World Forum for Harmonization of Vehicle Regulations**Working Party on Passive Safety****Sixty-sixth session**

UN Global Technical Regulation No. 7 (Head restraints)**Proposal for Amendment 1 of Phase 2 of UN Global
Technical Regulation No. 7 (Head restraints)****Submitted by the expert from the European Association of Automotive
Suppliers ***

"Figure 3-3

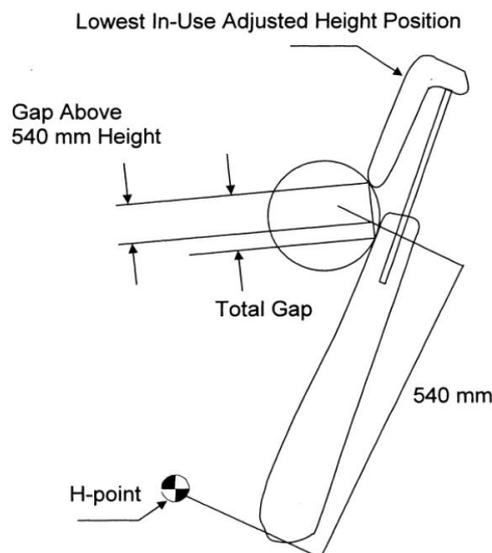
Annex 3, paragraph 2.3., amend to read:

"2.3. The area of measurement is anywhere between two vertical longitudinal planes passing at 85 mm on either side of the torso line and above ~~the top of the seat back~~ **a height of 540 mm."**

Annex 3, insert a new Figure 3-3, to read:

Portion of gap above 540mm.
